Response to
Request for Additional Information No. 442, Supplement 3

U. S. EPR Standard Design Certification
AREVA NP Inc.
Docket No. 52-020

SRP Section: 07.01 - Instrumentation and Controls - Introduction
SRP Section: 07.03 - Engineered Safety Features Systems
SRP Section: 07.09 - Data Communication Systems

Question 07.01-29:

Figure 7.3-1—Typical ESF Actuation
(Sheet 2 of 2)

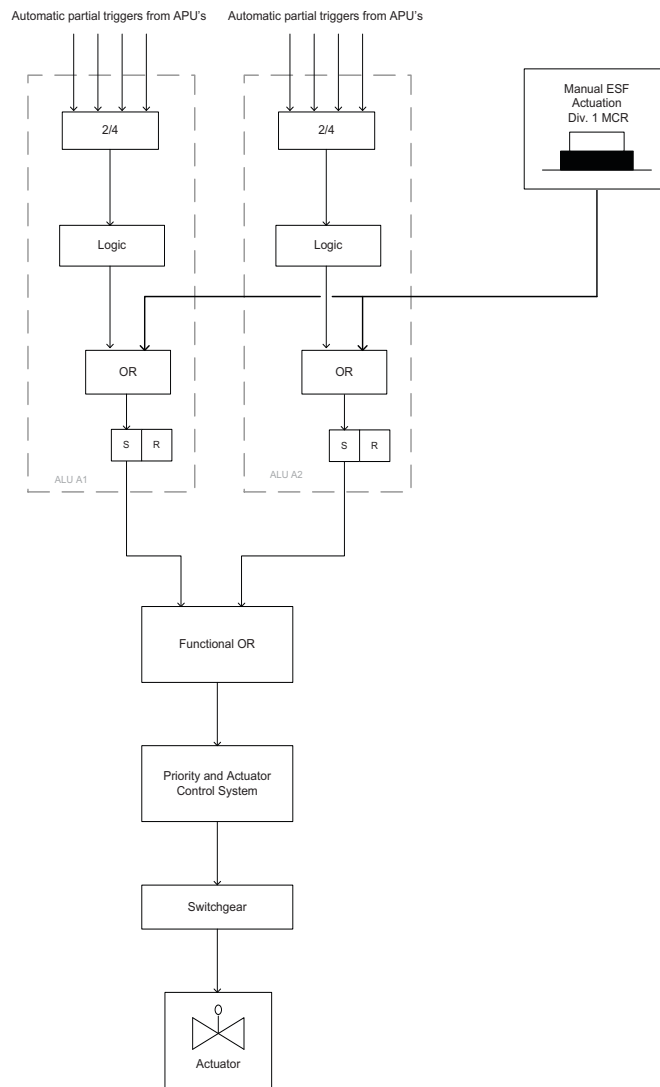
Clarify FSAR and technical report figures associated with manual engineered safety feature actuation.

10 CFR 52.47(a)(2) requires, in part, a description of structures, systems, and components sufficient to permit understanding of the system designs. The staff, noticed there are some differences between the logic drawings that depict a "typical ESFAS actuation sequence" in Figure 8-1 ANP-10281P, "US EPR Digital Protection System Technical Report, Revision 0, and Figure 7.3-1 of US EPR FSAR Tier 2, Section 7.3. The staff also observed that there is no manual actuation signal line depicted in either figure for ESF, whereas a manual actuation is shown for RT functions shown in Figures 7-4 and 7.2-3 of ANP-10281P, "US EPR Digital Protection System Technical Report, Revision 0, and US EPR FSAR Tier 2, Section 7.2, respectively. The staff presented its observations to the applicant in a teleconference and the applicant agreed to modify Figure 8-1 ANP-10281P, "US EPR Digital Protection System Technical Report, Revision 0, and Figure 7.3-1 of US EPR FSAR Tier 2, Section 7.3 to bring them in line with each other. The applicant also verbally committed to adding detail for manual actuation for each ESF figure to accurately reflect that this functionality does exist in the typical ESF actuation sequence.

U.S. EPR FSAR Tier 2, Figure 7.3-1, Sheet 2 will be added to show detail of the typical engineered safety features (ESF) manual actuation sequence. U.S. EPR FSAR Tier 2, Section 7.3.1.1 will be revised to reference the added figure.

U.S. EPR FSAR Tier 2, Section 7.3.1.1 will be revised and Figure 7.3-1, Sheet 2 will be added as described in the response and indicated on the enclosed markup.

The capability for component-level control of ESF system actuators is available to the operator on both the PICS and the SICS. Commands from the PICS are processed by the PAS and sent to the PACS for prioritization. Commands from the SICS are processed by the SAS and sent to the PACS for prioritization. For any ESF actuator commands from the SICS have priority over those from the PICS. The typical manual ESF actuation sequence is shown in Figure 7.3-1 (Sheet 2 of 2).
